The following is a comment on application 'P171532/O' by 'Ewen Sinclair'

OBJECTION TO PLANNING APPLICATION NUMBER: P171532/O

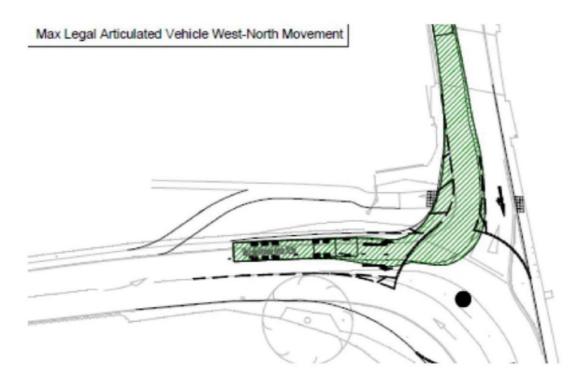
The biggest concern is how the Mini Roundabout is viewed by the Transport Consultants. See below an extract from Drawing No. LUE-BWB-HML-XX-DR-D-103 S2 P5. Whoever has produced the swept paths is either incompetent or is deliberately trying to mislead the Planning Committee. The drawing shows the vehicle travelling from Hereford Road onto Bromyard Road, travelling over a significant earth embankment. If this route were taken the vehicle would either tip over or become trapped. The route shown on the swept path would require major Civil Engineering Works to be achievable; none are listed in the report.
